Public House Creative

Sample Project – Lot 12

Prepared For Sample Builder Co.

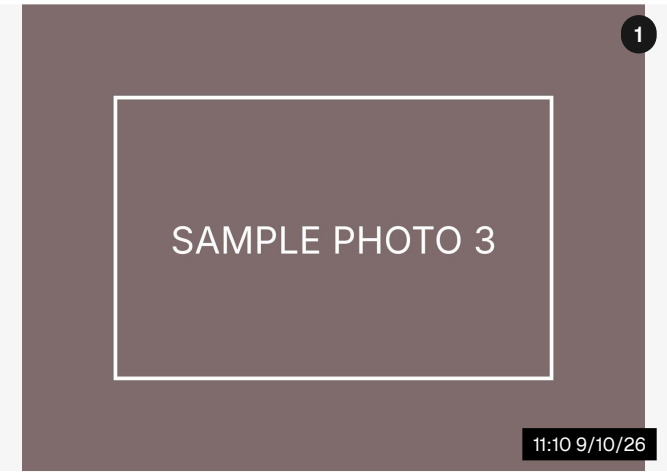
No outlet rough-in on the island wall. Outlet required by plan.

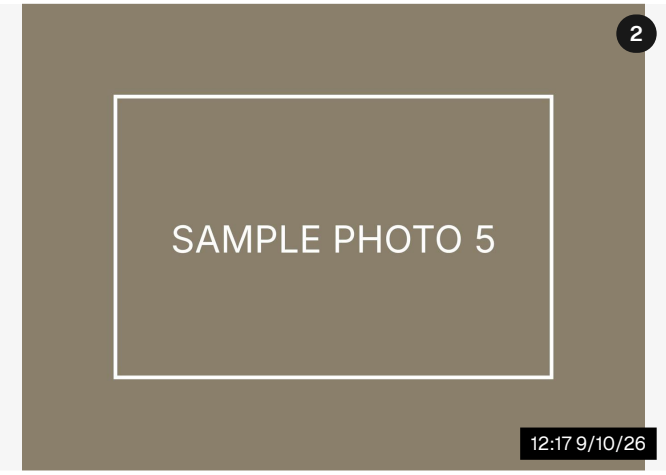
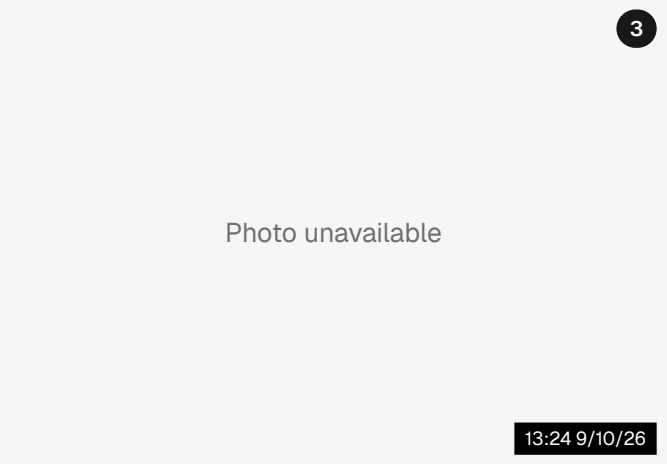
Wall bowed about 3/4 in. at the pantry. Shim or re-frame so the tall cabinet sits plumb.

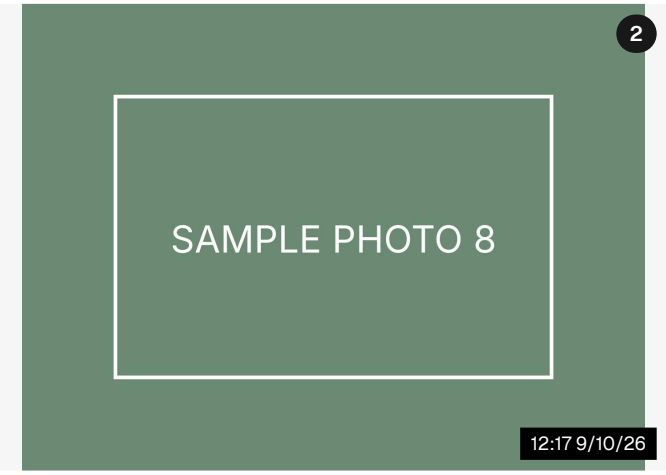
Window sill is lower than the tub deck. Confirm height with the builder before the surround is ordered.
